**HARDY COUNTY RURAL DEVELOPMENT AUTHORITY
HARDY COUNTY, WEST VIRGINIA**

AMERICAN WOODMARK INDUSTRIAL ACCESS ROAD

ADDENDUM #1

THRASHER PROJECT #030-2970

HARDY CO. RURAL DEVELOPMENT AUTHORITY
CONSTRUCTION PLANS FOR THE
INDUSTRIAL ACCESS ROAD
HARDY COUNTY, WEST VIRGINIA
STORM PROFILE

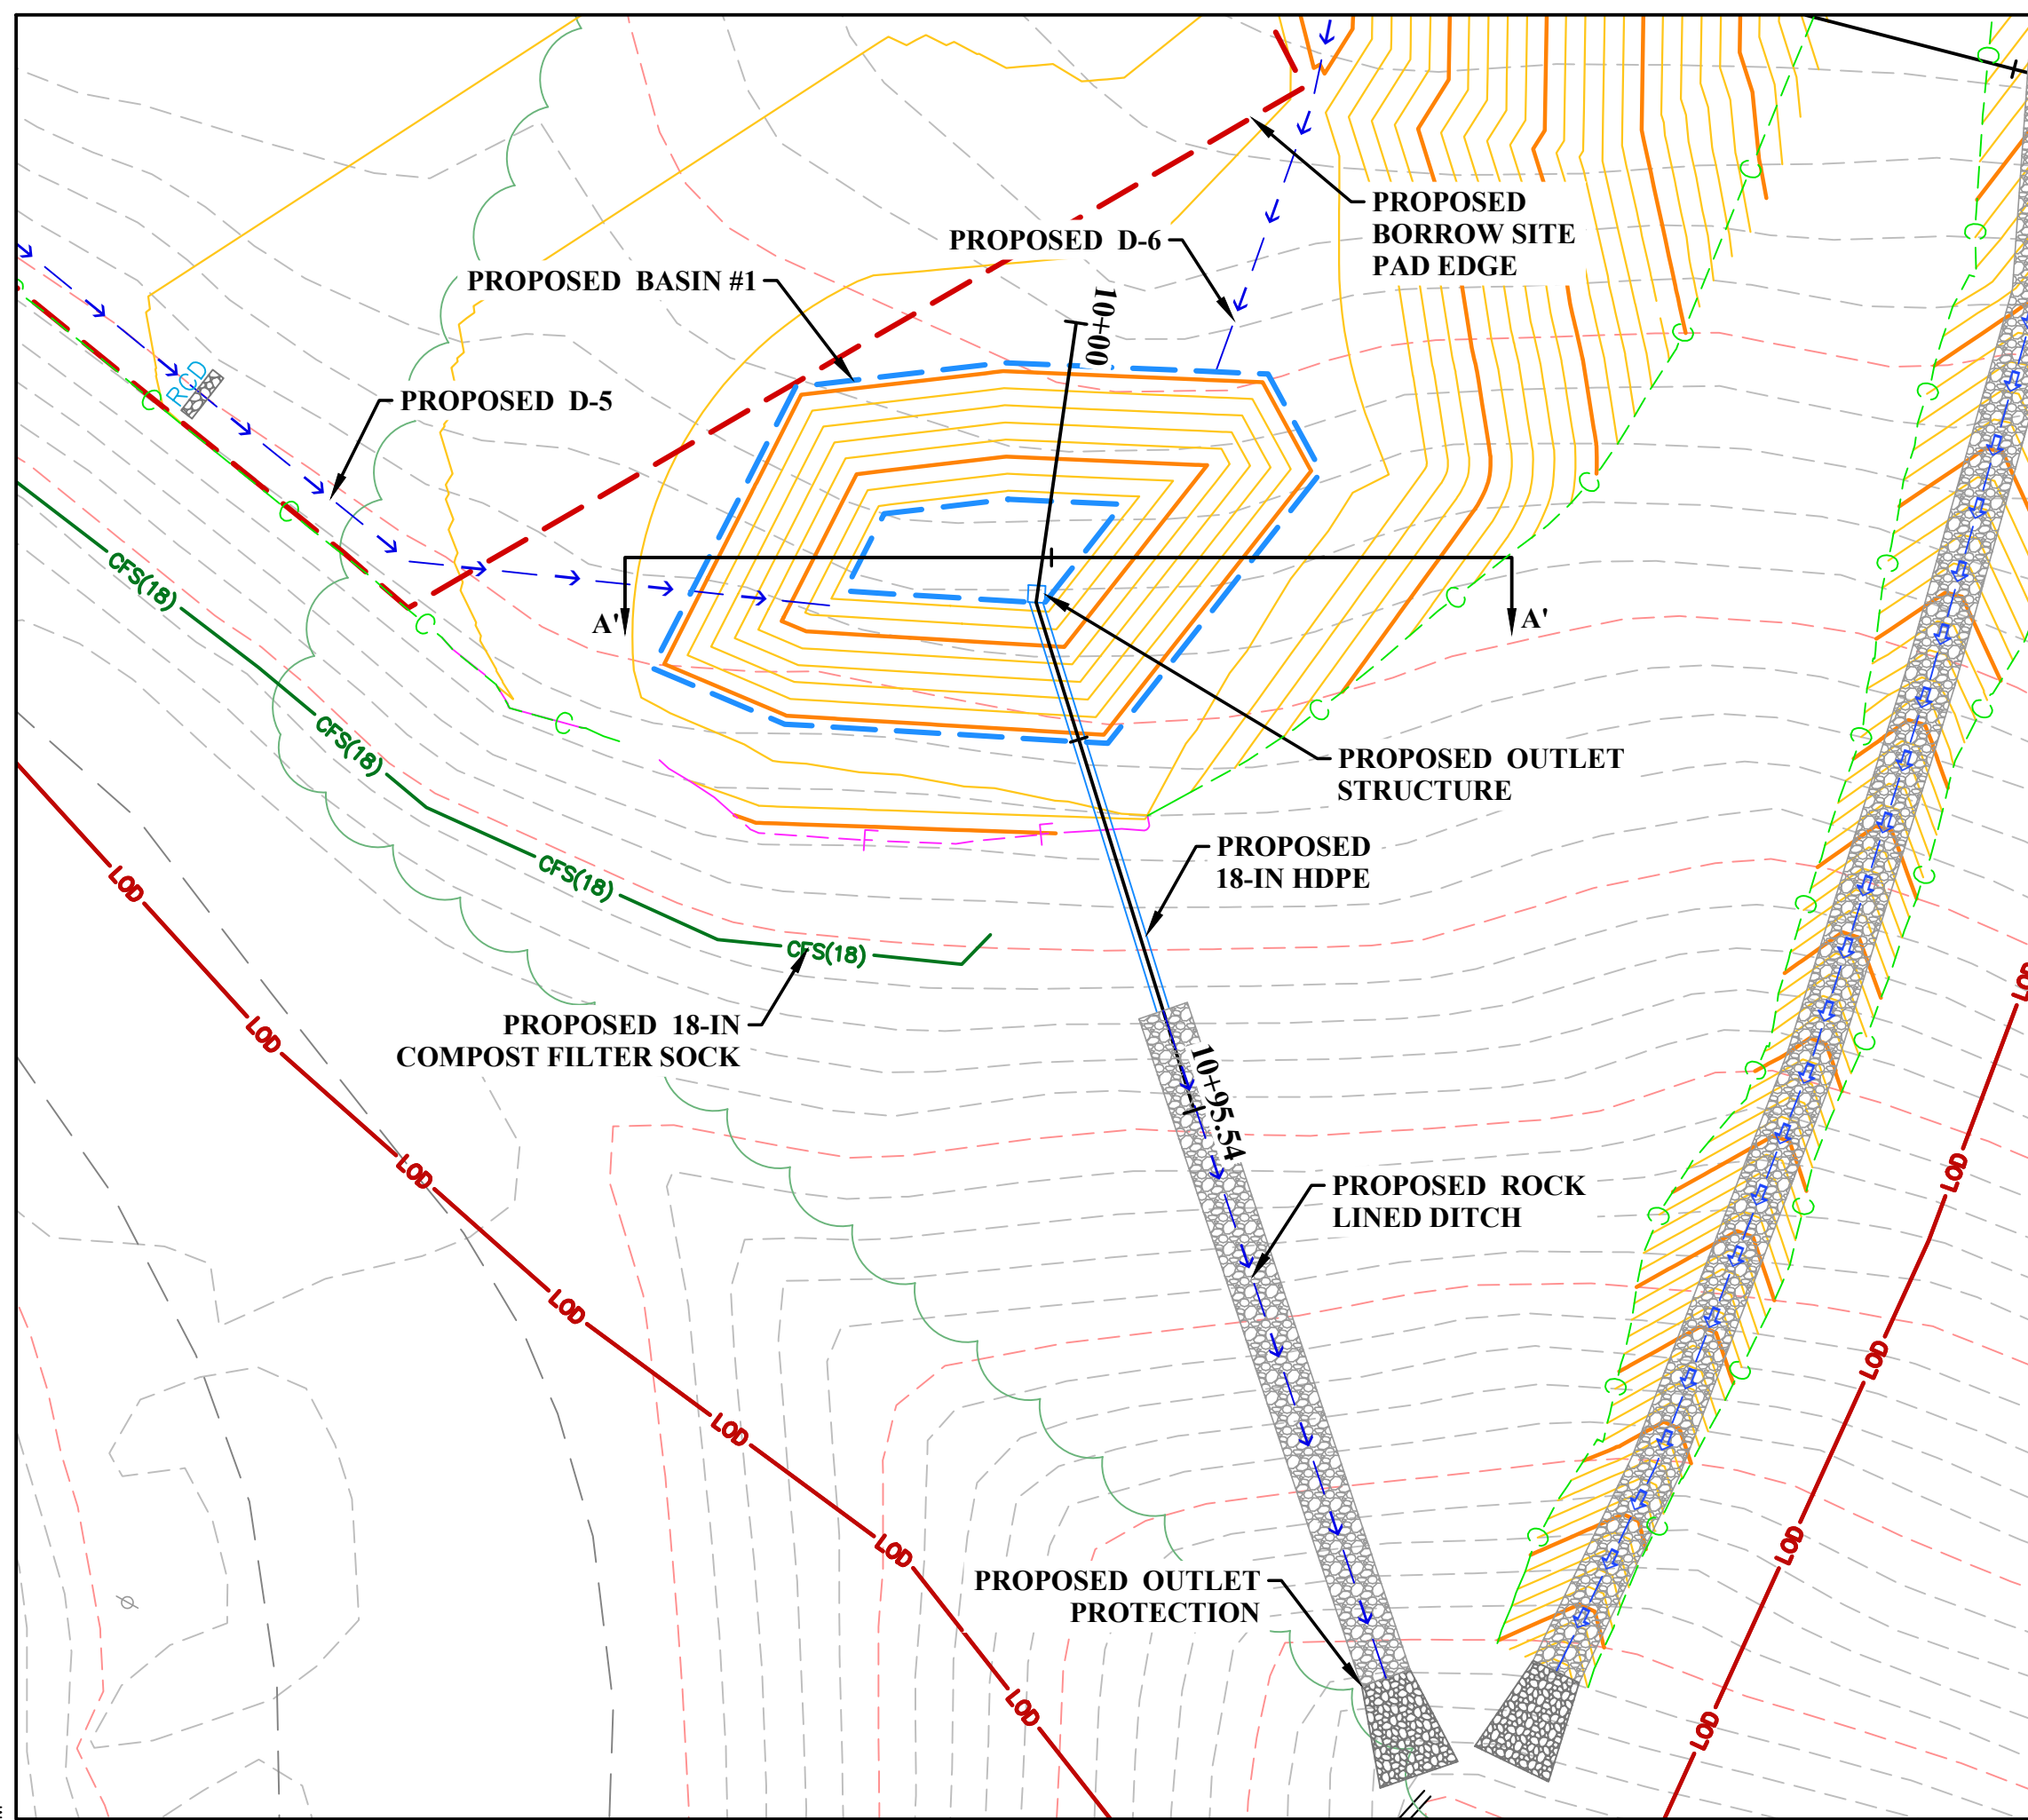
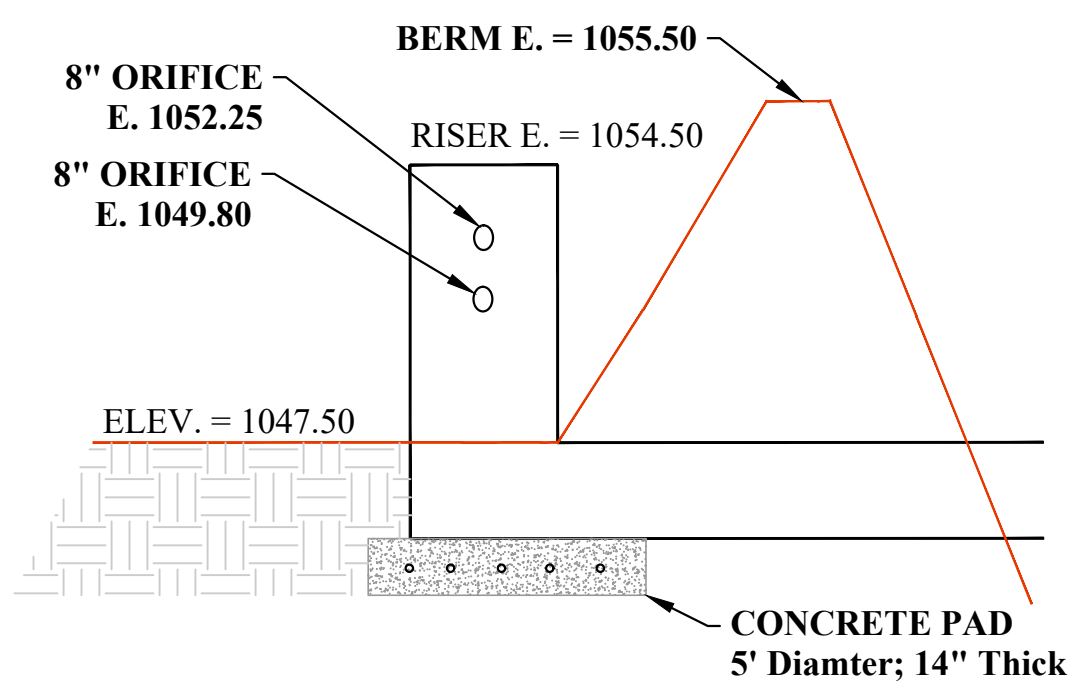
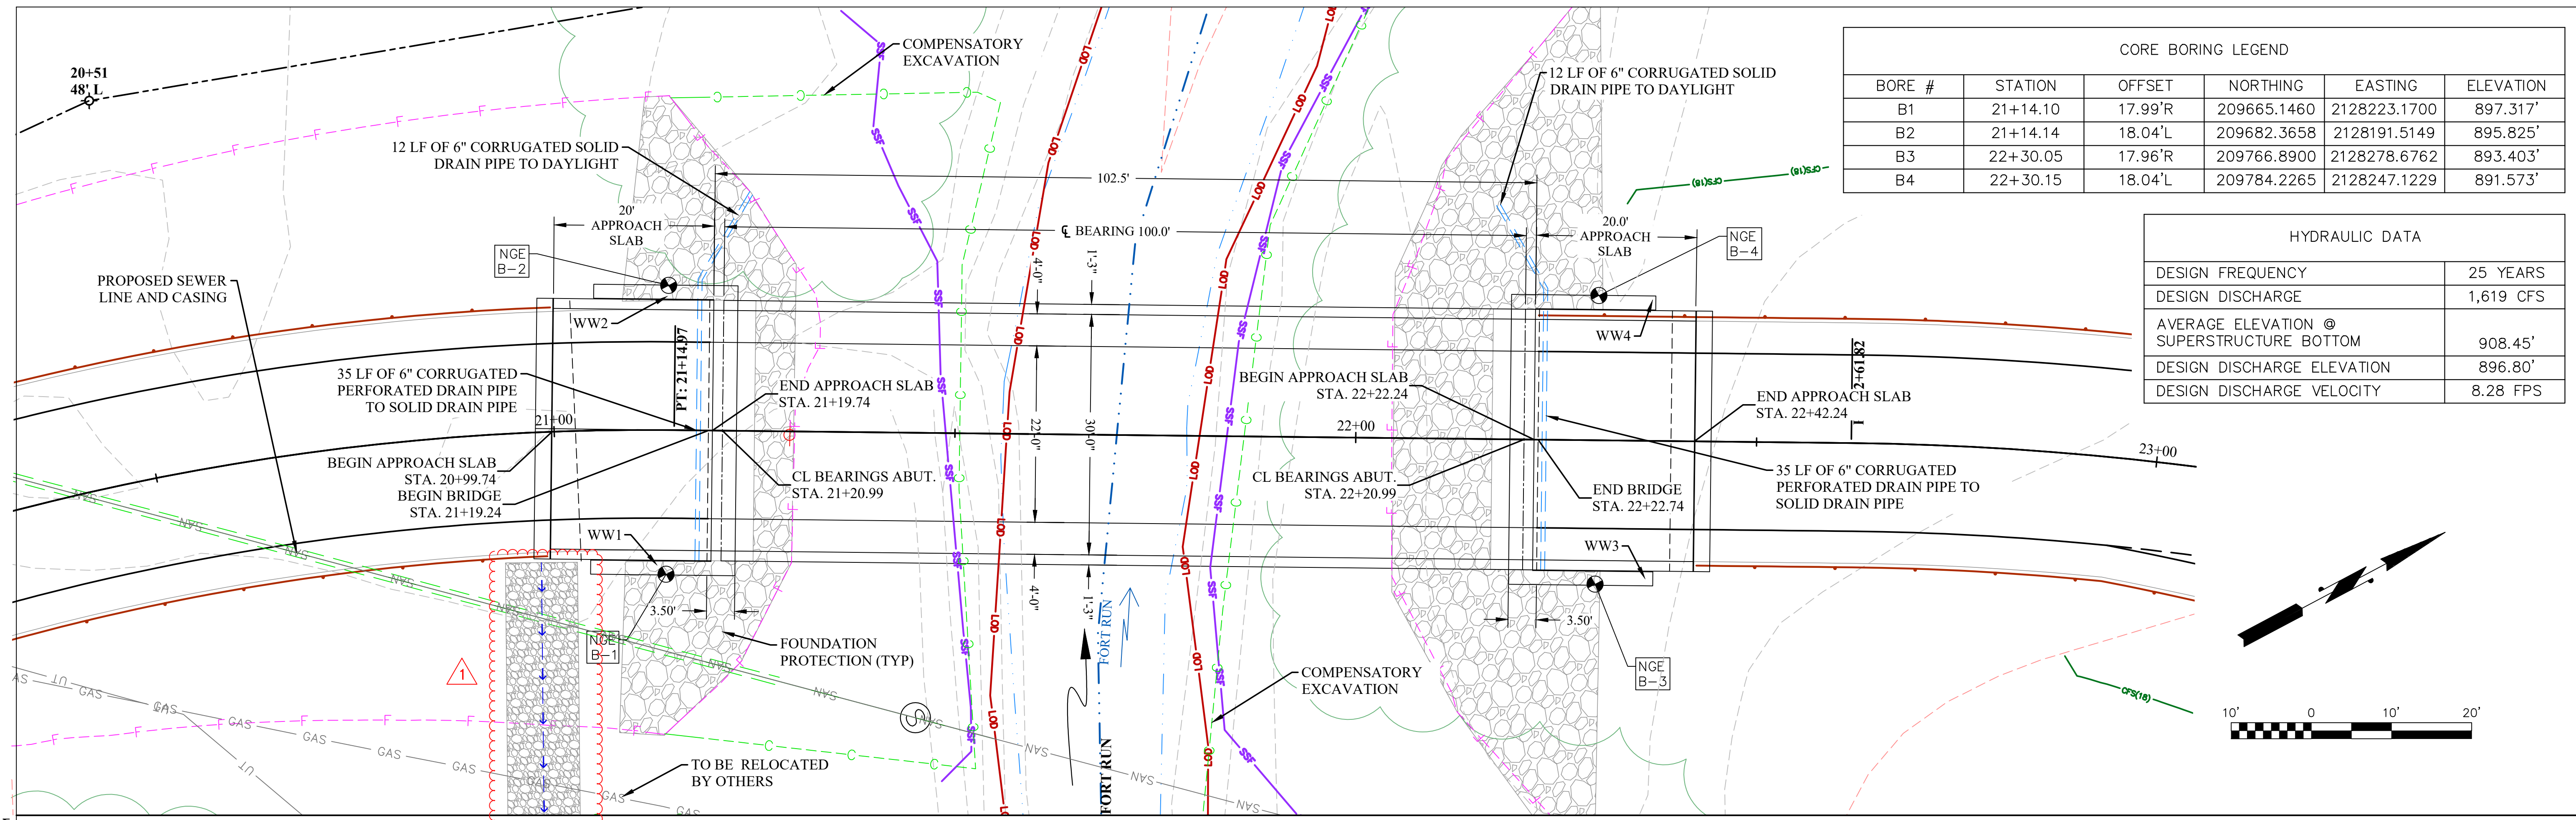
Can you provide a detail for the basin in the borrow area with outlet details?

Can you provide additional information for proposed basin #1? I do not see any specification for the outlet structure, outlet pipe, or spillway.

Plan Sheet 18.1 was added to the plans to provide the basin details.

Plan Sheet 18.1 was added to the plans to provide the basin details.

NO.	BY	DATE	DESCRIPTION
1	REM	10.13.2022	ADDENDUM 1 - ADDED STORM BASIN DETAIL

SHEET No.
29

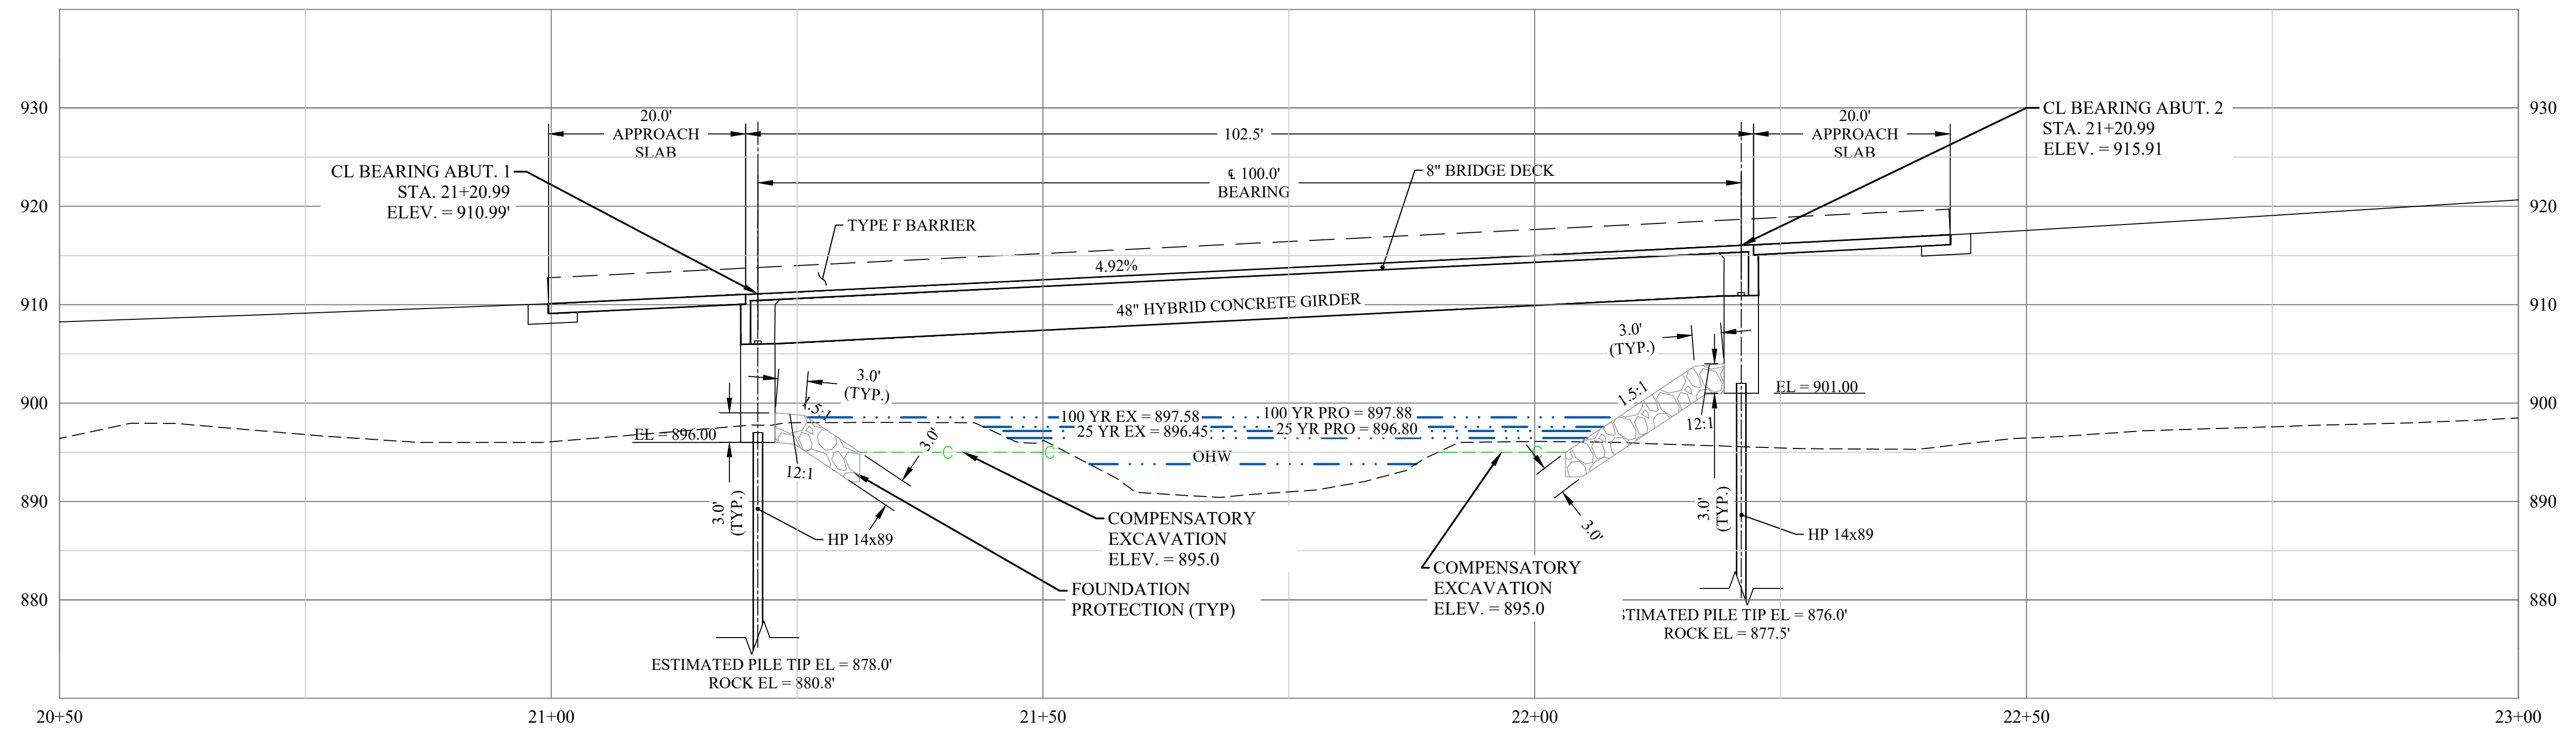
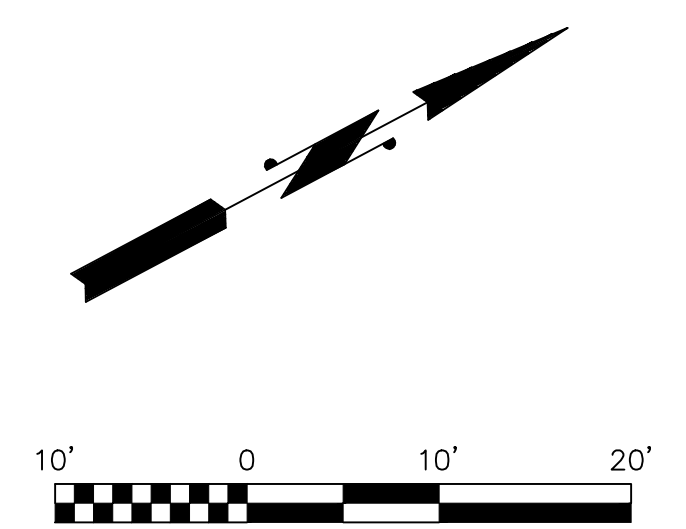
1. Cover Sheet – Sheet Index was updated to add Plan Sheet 18.1
2. Plan Sheet 4 – updated quantities
3. Plan Sheet 14 – updated wingwall invert elevation and added channel D-9
4. Plan Sheet 18 – updated the 48” RCP profile
5. Plan Sheet 18.1 – plan sheet added
6. Plan Sheet 29 – replace the concrete block flume with rip rap lined ditch
7. Plan Sheet 30 – updated bridge notes

The concrete flume has been removed from the construction drawings and replaced with a rip rap lined ditch. See updated sheets 14 and 29.

REVISION NUMBER	REVISED SHEETS	BY	DATE	DESCRIPTION
1	1,4,14,18,18.1,29,30	BM	10.13.2022	UPDATED SHEET INDEX; UPDATED QUANTITIES; UPDATED INVERT ELEV; UPDATED 48" RCP PROFILE; ADDED STORM BASIN DETAIL; REPLACED CONCRETE BLOCK FLUME WITH RIP RAP LINED DITCH; UPDATED BRIDGE NOTES
